From: Roads Eastern Srit
Sent: 10 March 2015 15:00
To: [REDACTED]
Subject: York Street Interchange Formal Consultation

From: Andrew Fleming [REDACTED]
Sent: 09 March 2015 23:00
To: Roads Eastern Srit
Subject: York Street Interchange Proposals

Proposed Road car-centric layout for York Street Flyover at YSI, Belfast (above)

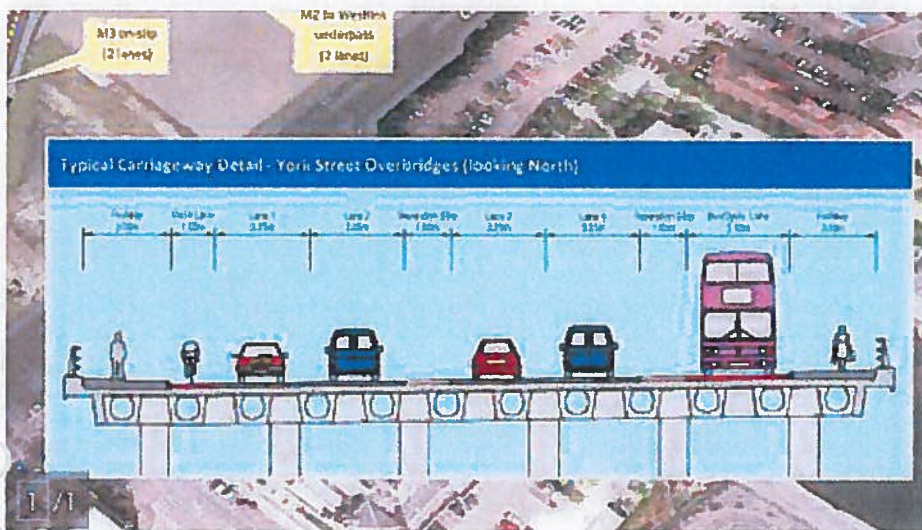
I have a problem with the lack of cycling provision of this scheme. You see, it says in the non-technical summary:

there is a real lack of ambition oozing from these words, and unfortunately this is reflected in the proposals.

"Existing provision for pedestrians and cyclists on York Street would be maintained as a minimum, with an expected improvement for non-motorised users at the junctions from the removal of a significant volume of traffic."

I think that in the future, cyclists will dominate the landscape, therefore, infrastructure should be able to facilitate that. By facilitating it now, there will be less need to spend money on it later. A nearby development is the Ulster University Belfast Campus which is relocating from Jordanstown. As part of the plans, there will be a bicycle parking facility for 200 bicycles at Fredrick Street. Once most of the Jordanstown campus relocates to Belfast, the number of pedestrians and cyclists in the area will increase dramatically. Surely, a redesign of this flyover is needed.

How the proposal could be better for cyclists.

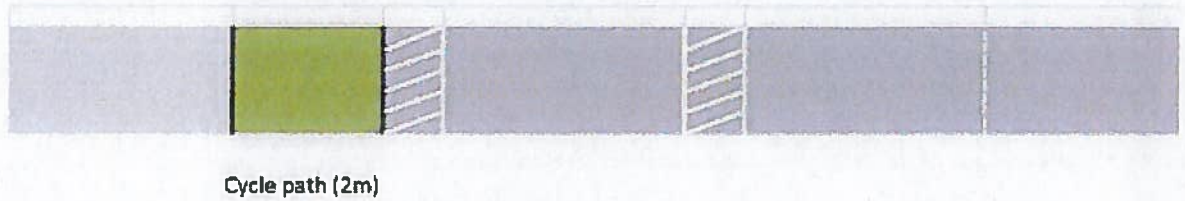
I follow a cyclist blogger from Belfast who has blogged about this project. <https://stripymoggie.wordpress.com/2015/02/05/york-street-interchange-no-space-for-cycling/> He has suggested the following redesign of the flyover to dedicate two dedicated, **protected** cycle lanes either side.

Here's my redesign of the flyover:

The reduced traffic levels mean we can remove one of the northbound lanes and redistribute the space for segregated cycle paths either side, with wide buffer zones. The paths must run from Dock Street to the Inner Ring, with their own traffic lights across the Westlink off-slip and M2 slip road.
